Subject: **Bid No. 7970-W3, Arena Seating Installation – DCU Center / DPF**

ADDENDUM NO. 4

SKA – 1 Section 112 Spanner Deck Resurfacing

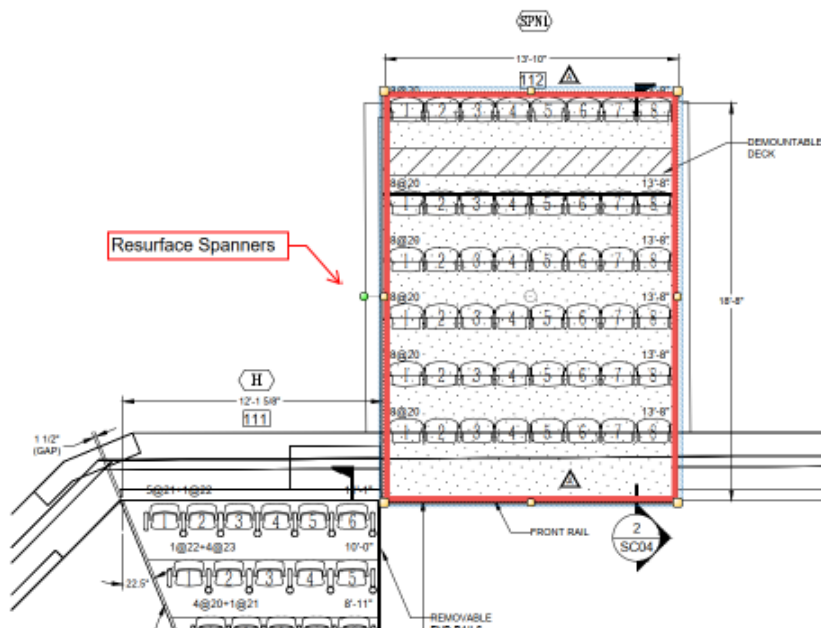
1. At Section 02 41 19 Selective Demolition Arena Part 3 Execution 3.4 Selective Demolition, General ADD, "D. At Seating Section 112 demolish and dispose of existing aluminum decking as shown in SKA-1 of this addenda." AND "E. Demolish and dispose of existing deck supports. Do NOT discard steel I-beams."
2. At Section 12 63 00 Arena Seating Installation Part 3 Execution 3.2 Installation ADD "F. Resurface existing spanner decks in Section 112 to match new bleacher aluminum; see SKA-1 of this addenda. All installation materials and fasteners provided by chair manufacturer, Hussey Seating. Drill holes for new deck supports into existing steel I-beams. Bolt together deck supports, aluminum nosing, and steel riser. Install new decking and end caps. Attach rail sockets and front rails. Drill through decking to install new chairs and attach backer plates per manufacturers requirements."
